UNITED STATES PATENT AND TRADEMARK OFFICE

APPLICATION NO.	FILING DATE	FIRST NAMED INVENTOR	ATTORNEY DOCKET NO.	CONFIRMATION NO.
10/714,848	11/18/2003	Koji Mackawa	8014-1071	3156
466	7590	09/07/2005	EXAMINER	
YOUNG & THOMPSON 745 SOUTH 23RD STREET 2ND FLOOR ARLINGTON, VA 22202			NGUYEN, CHAU N	
			ART UNIT	PAPER NUMBER
			2831

Office Action Summary

DETAILED ACTION

FIG. 2

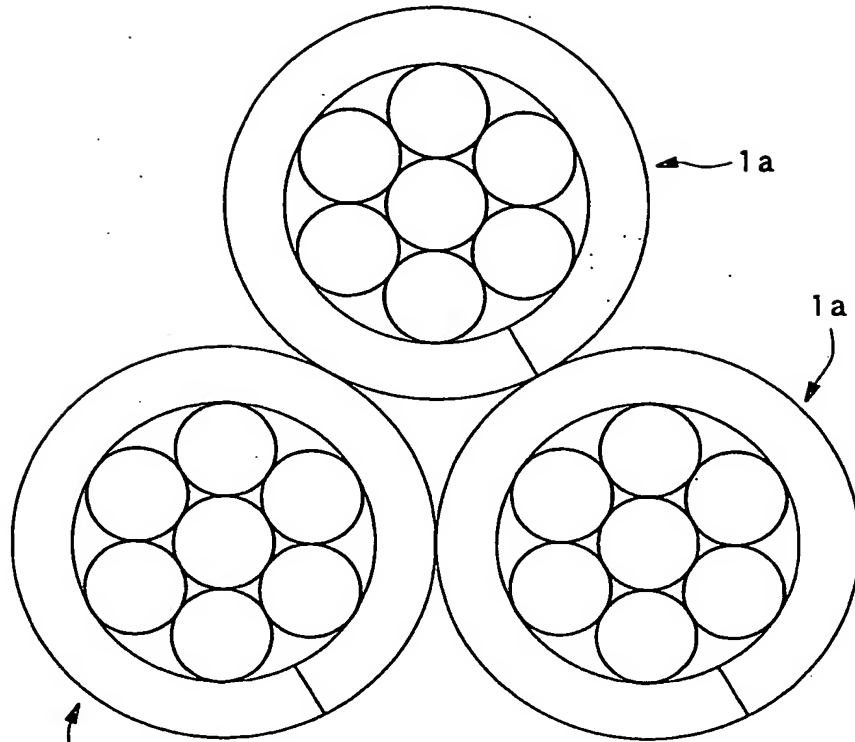
Figures 1-3 of AAPA discloses the invention substantially as claimed including the electric cord being connected between a vibrator and an input terminal in which the same electric current is flowed through the wires and each wire comprising a plurality of uninsulated core threads (11). Figures 1-3 of AAPA does not disclose the wires being electrically insulated from one another or the surface of the conductor (12), which is wound on the surface of the core thread (11), being covered with an insulator. Taylor et al. discloses an electric cord (Figs 1-2) comprising a plurality of wires (10) which are electrically insulated from one another. Taylor et al. discloses that in the case of an uninsulated multistranded conductor of the known art, the fact of its uninsulation causes it to behave as though it is a solid conductor of a given overall gauge, and the audio signal is subjected to skin effect resulting in a negative alteration of the audio signal. Furthermore, uninsulated stranded conductors are subject to the effects of the corrosive atmosphere. As the wires aged, the audio signal is deteriorated (col. 1, lines 53-63).

Applicant argues that the plurality of strands (10) of Taylor et al. are insulated wires, while the core threads (21) of the present invention are not insulated within each wire. Applicant has confused between strands, core threads, conductors and wires. Figure 3 of AAPA discloses each wire (1b) comprising three conductors (1a, see Figure 2 of AAPA), each conductor (1a) comprising core threads (11) which are **uninsulated** core threads and which are wrapped around by conductive element (12, see Figure 1A of AAPA). Accordingly, Figures 1-3 of AAPA discloses the invention substantially as claimed including each conductor comprising core threads which are uninsulated core threads. Figures 1-3 of AAPA does not disclose the conductors (1a) being insulated from each other. Taylor et al. teaches each wire (B, Figure 1 corresponding to each wire 1b of Figure 3 of AAPA)

comprising conductors (10) which are insulated from each other by insulating (12). Taylor et al. is relied upon for the teaching of insulating conductors from each other in a bundle to improve the signal transmission and to protect the conductors. The feature of each conductor comprising a plurality of uninsulated core threads is disclosed in Figures 1-3 of AAPA.

1a = Wire 10 of Taylor
1b = bundle B of Taylor
